Park: Sampson State Park

Project Name: New Regional Maintenance Storage Building

SUBJECT: Addendum 1

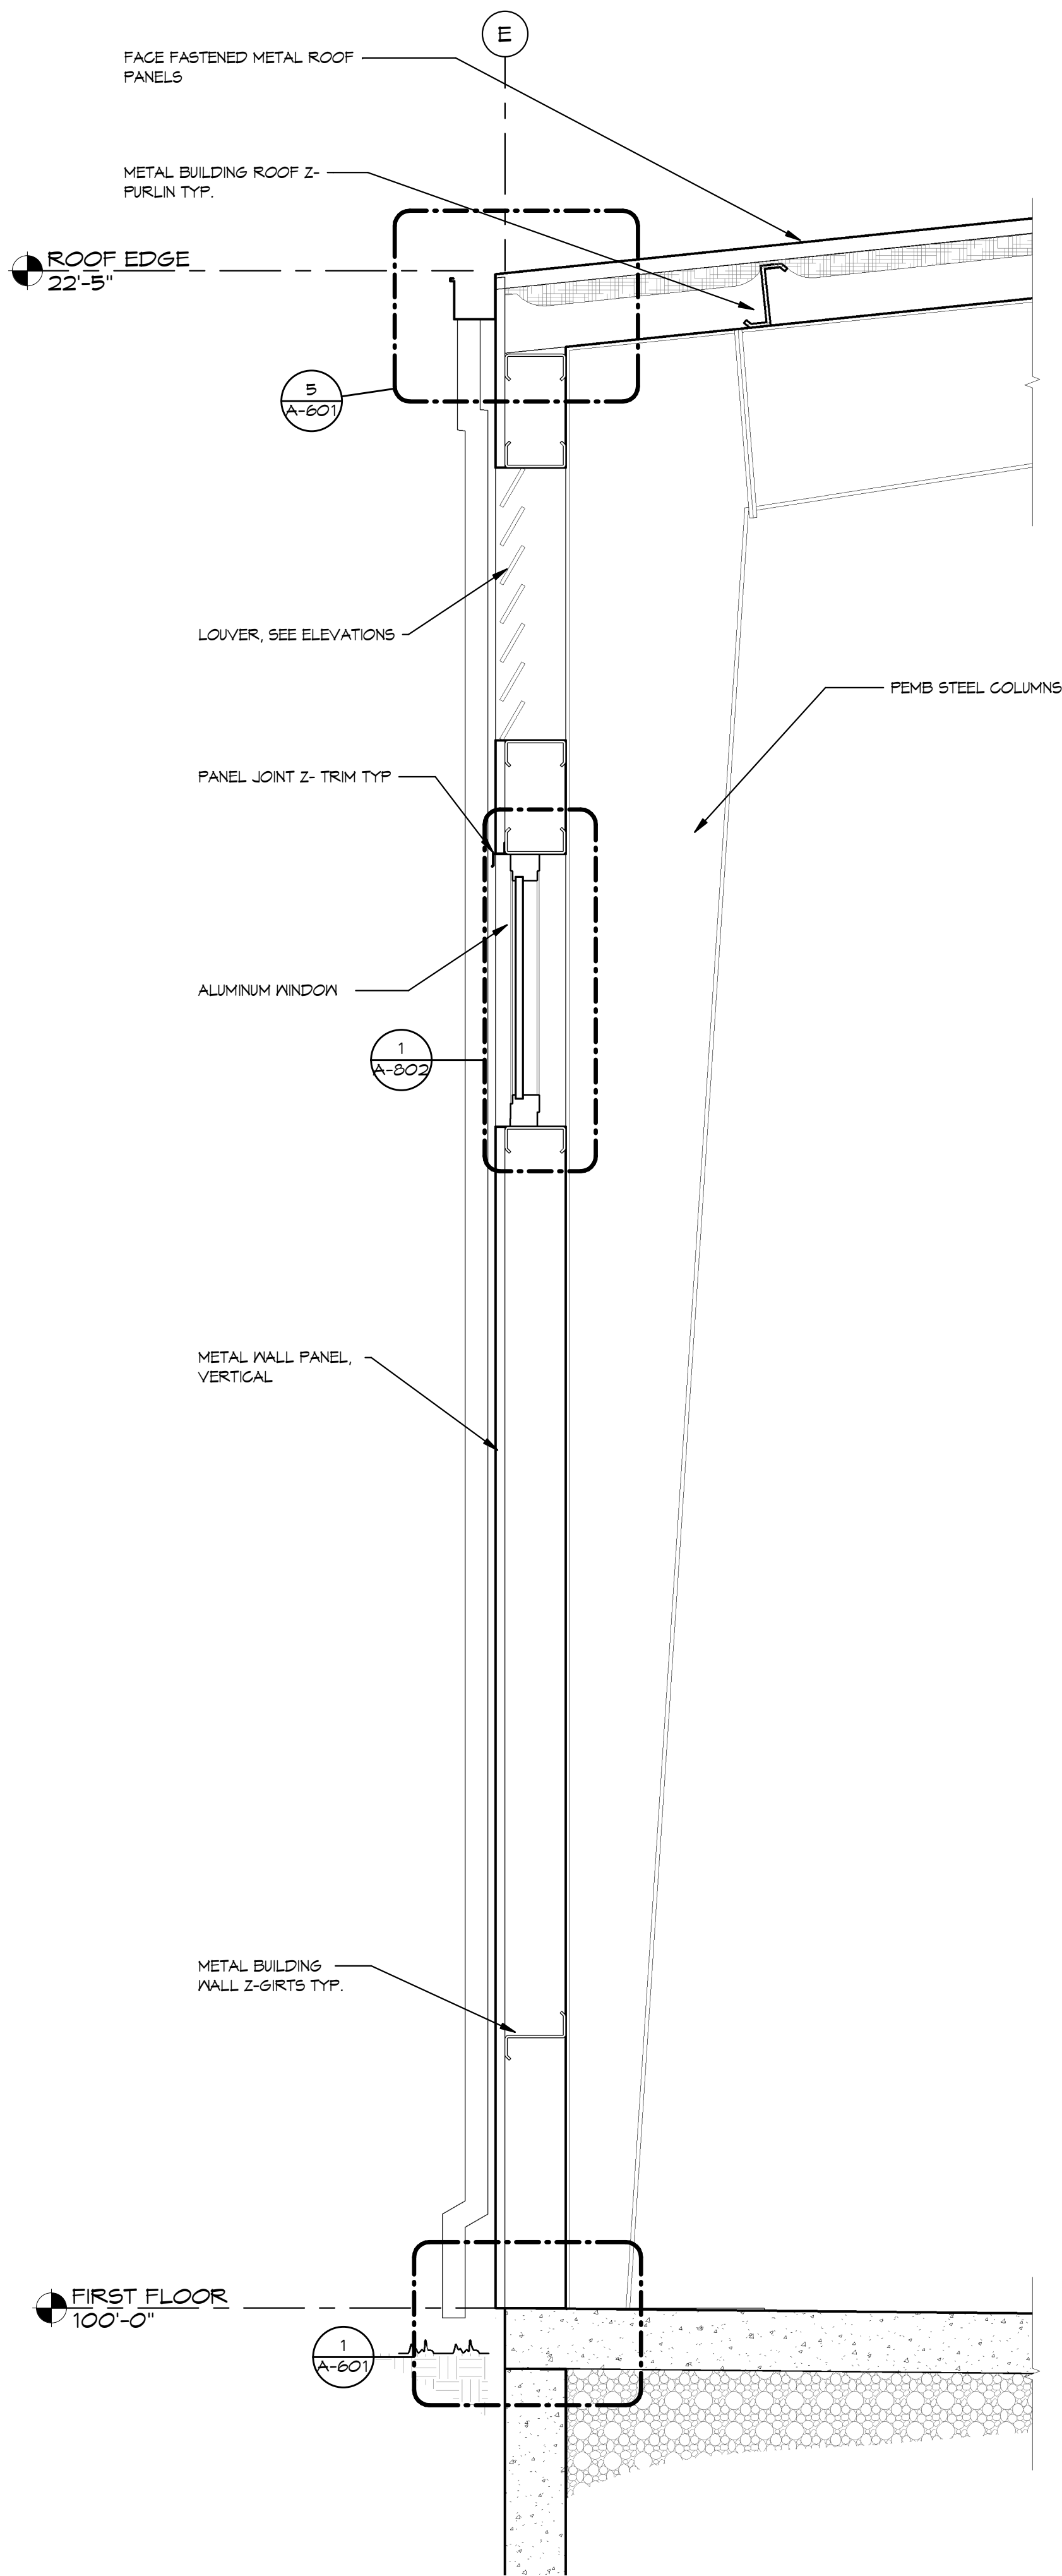
Q2: Spec section 089119 Fixed Louvers Drawing: A, M – L4 only shows once on the elevations but twice on the schedule. Is there only 1?

A2: There are two L4 louvers; the second L4 louver is located on the interior wall of the wash bay. See drawing A-102

2 WALL SECTION - INSULATED OH DOOR
SCALE: 3/4" = 1'-0"

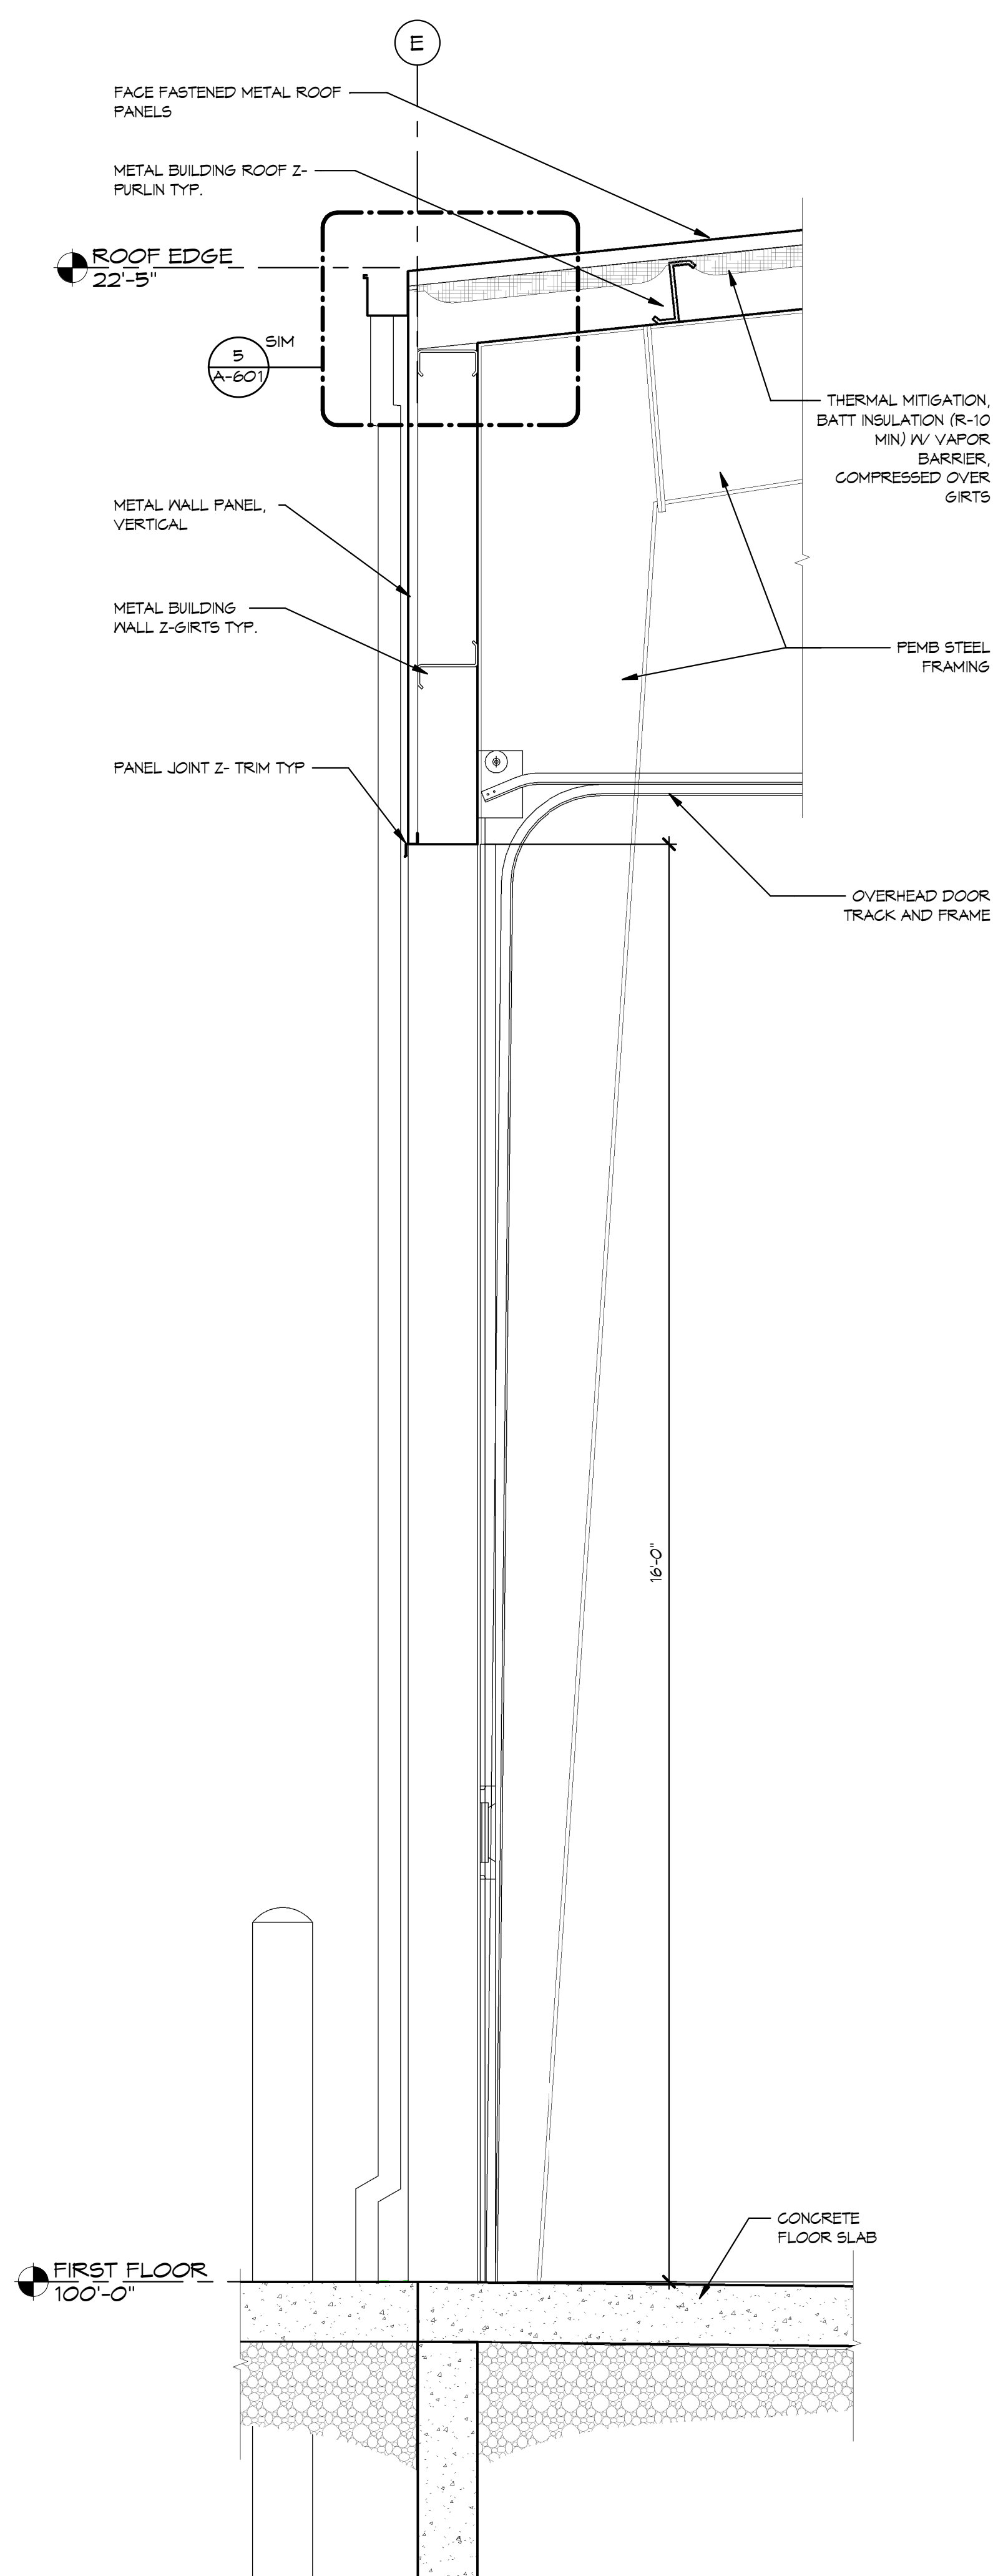
Q10: Spec section 054000 CFMF, Drawings A-501, detail 2. No comments/wall ty is called out above the overhead doors. Please provide the components or wall tag. See attached.

Q11: Spec section 054000 – CFMF, Drawing A-501, detail 2. What ceiling framing components are needed at truck wash bay? The wall to wall stretches over 20 feet. Is structural framing required? See attached.

A10: the wall in question, above the OH doors, is wall type B.1. matching the wall adjacent to the door. See details on A-801 for more information regarding the suggested framing around the OH opening.

A11: Refer to details on A-502 that call for "SUSPENSION CEILING GRID". Systems such as Armstrong FRAMEALL® Flat Drywall Grid, USG Drywall Suspension System, or Certainteed 1 1/2" Drywall Suspension System, or similar, would all be suitable.
